Docket No. 72-1014, Certificate of Compliance (CoC) No. 1014

Subject: Transmittal of RSI Responses Supporting HI-STORM 100 LAR 1014-11

## **Enclosure 1 to Holtec Letter 5014810**

### **LAR 1014-11, REVISION 0**

**FIGURE 3.III.2: VON MISES STRESS DISTRIBUTION IN MPC-68M FUEL BASKET UNDER 60g LOAD**

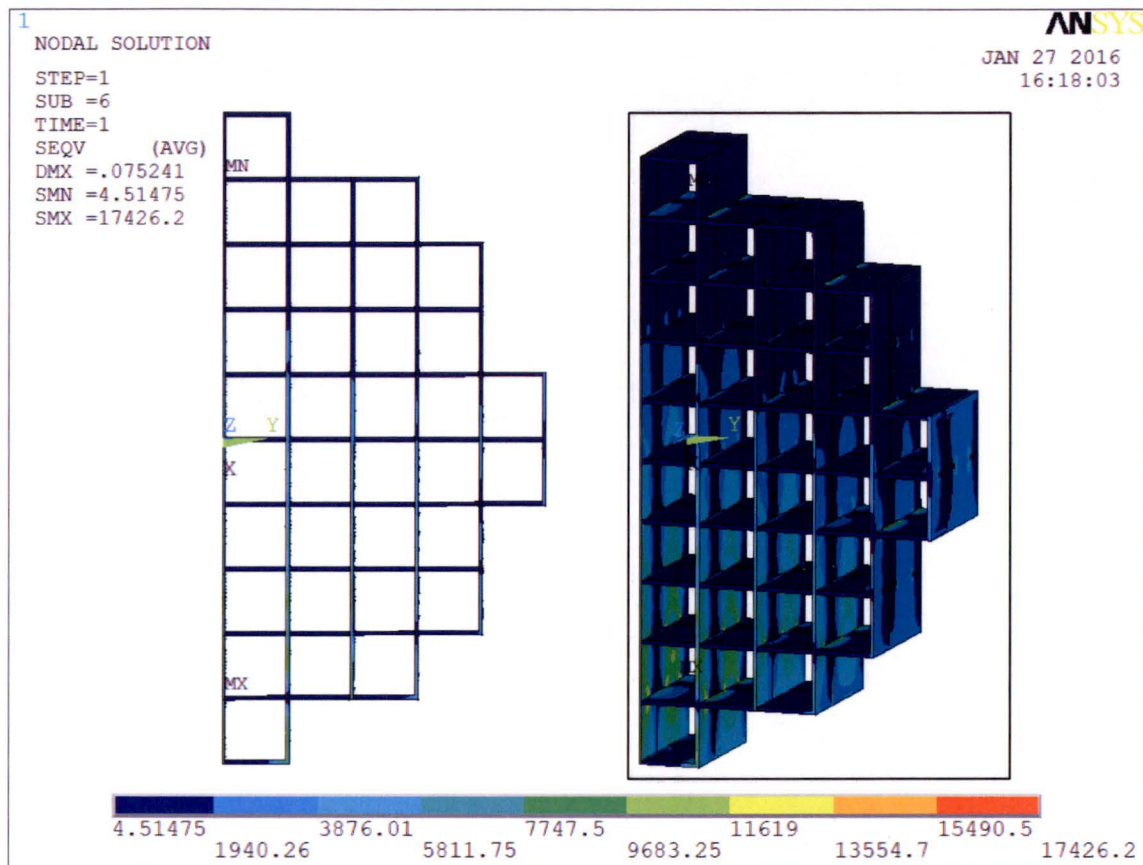
The stress and strain distributions in the fuel basket panels at ~~6070~~g are shown in Figures 3.III.2 and 3.III.3, respectively. These figures show that the state of stress in the fuel basket panels is primarily elastic. The fuel basket displacements are plotted in Figure 3.III.4. Table 3.III.4 compares the maximum lateral displacement in a fuel basket panel (relative to its end supports) with the deflection limit specified in Subsection 2.III.0.1.

FIGURE 5.F.1; ~~ORIGEN-S CALCULATED BURNUP VERSUS DECAY HEAT FOR VARIOUS ENRICHMENTS~~

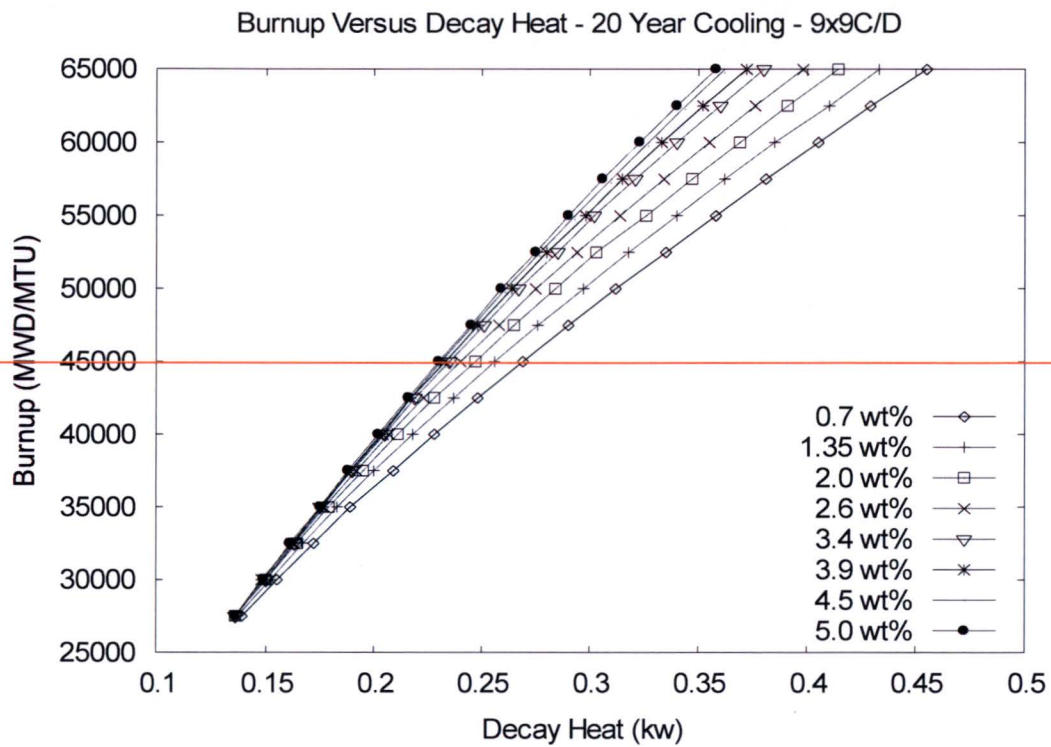
[INTENTIONALLY DELETED]

FIGURE 5.F.2; ~~A COMPARISON OF THE BURNUP VERSUS DECAY HEAT CALCULATIONS FROM ORIGEN-S, THE ORIGINAL CURVE FIT, AND THE ADJUSTED CURVE FIT FOR AN ENRICHMENT OF 0.7 WT.% <sup>235</sup>U.~~

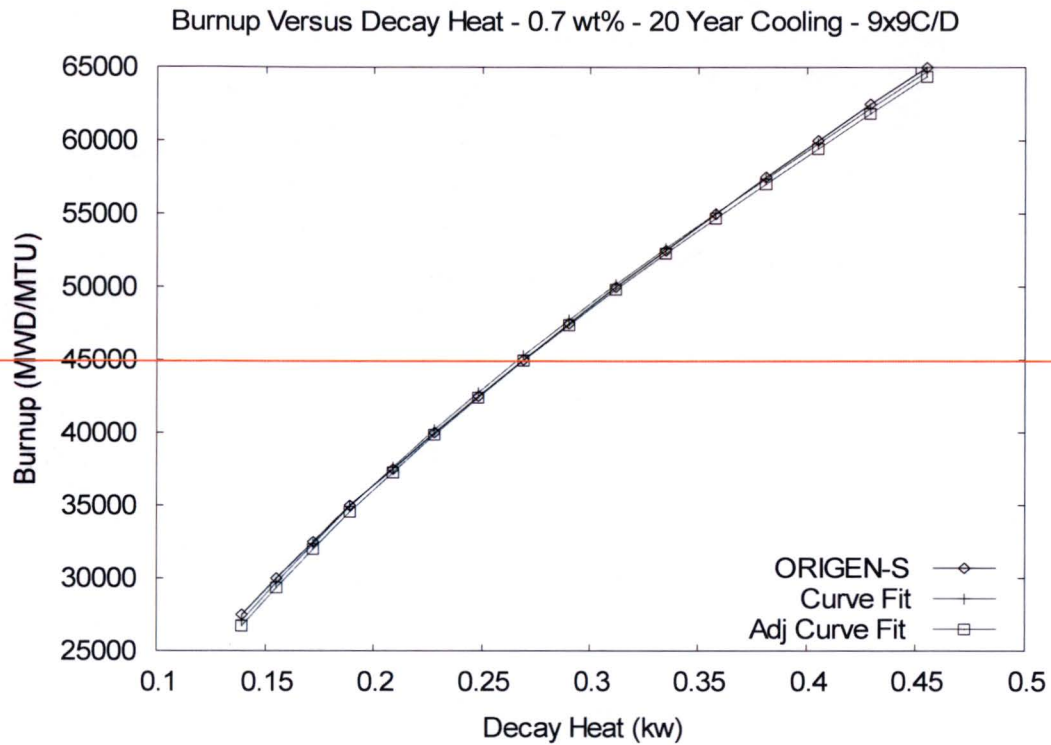
[INTENTIONALLY DELETED]

FIGURE 5.F.4; ~~A COMPARISON OF THE BURNUP VERSUS DECAY HEAT CALCULATIONS FROM ORIGEN-S, THE ORIGINAL CURVE FIT, AND THE ADJUSTED CURVE FIT FOR AN ENRICHMENT OF 5.0 WT.% <sup>235</sup>U.~~

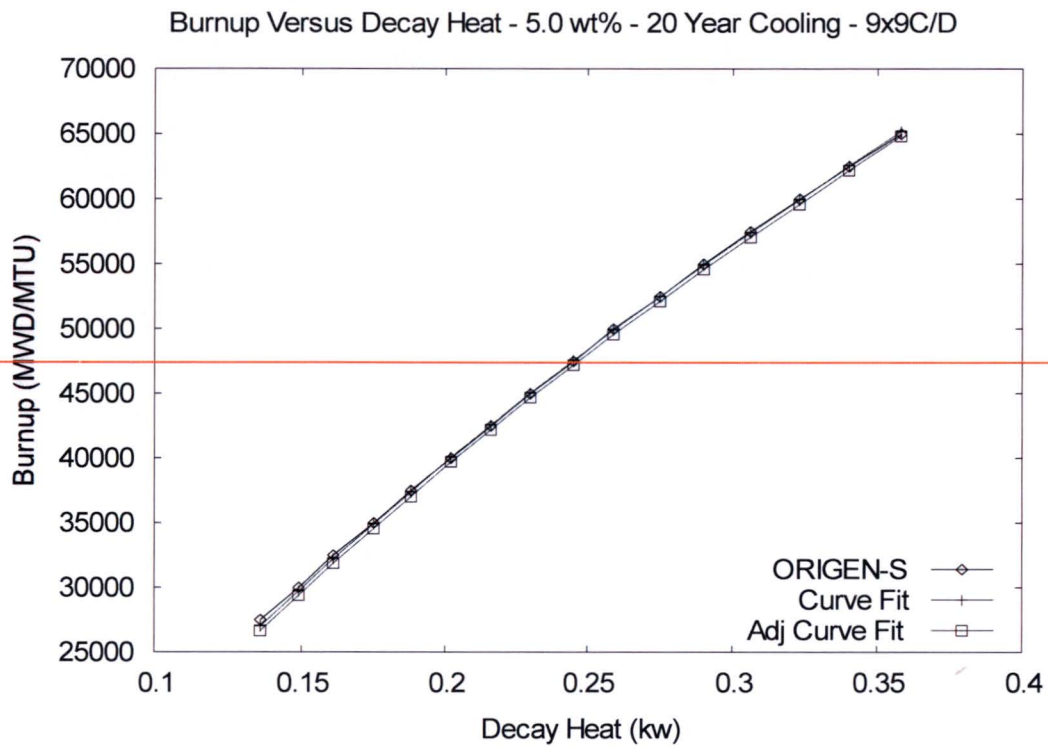
[INTENTIONALLY DELETED]

FIGURE 5.F.6; ~~A COMPARISON OF THE CALCULATED BURNUPS USING THE CURVE FIT AND THE ADJUSTED CURVE FIT FOR VARIOUS ENRICHMENTS. ALL ORIGEN-S CALCULATIONS YIELDED A BURNUP OF 45,000 MWD/MTU.~~

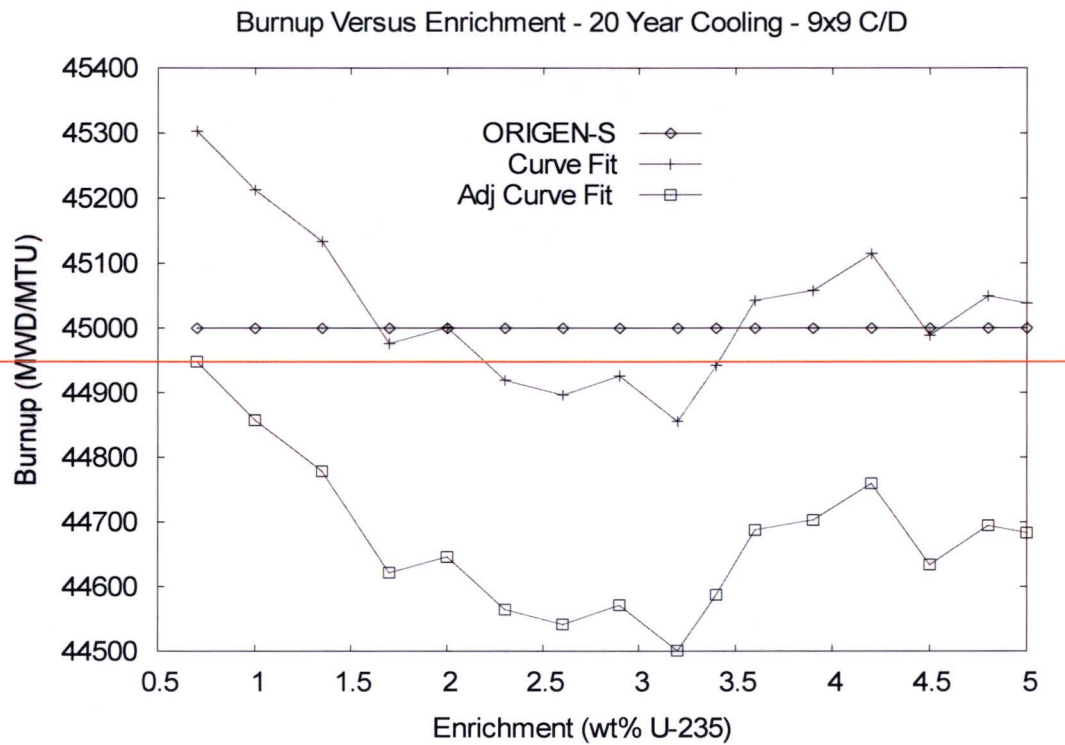
[INTENTIONALLY DELETED]

FIGURE 5.F.7; ~~A COMPARISON OF THE CALCULATED BURNUPS USING THE CURVE FIT AND THE ADJUSTED CURVE FIT FOR VARIOUS ENRICHMENTS. ALL ORIGEN-S CALCULATIONS YIELDED A BURNUP OF 65,000 MWD/MTU.~~

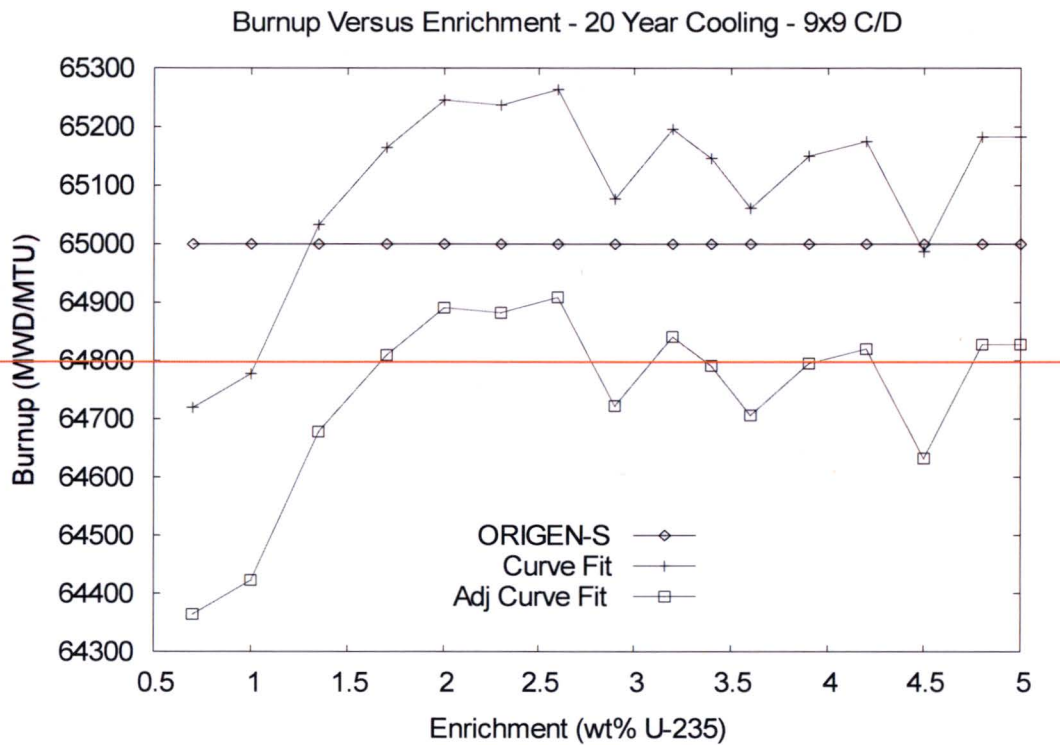
[INTENTIONALLY DELETED]
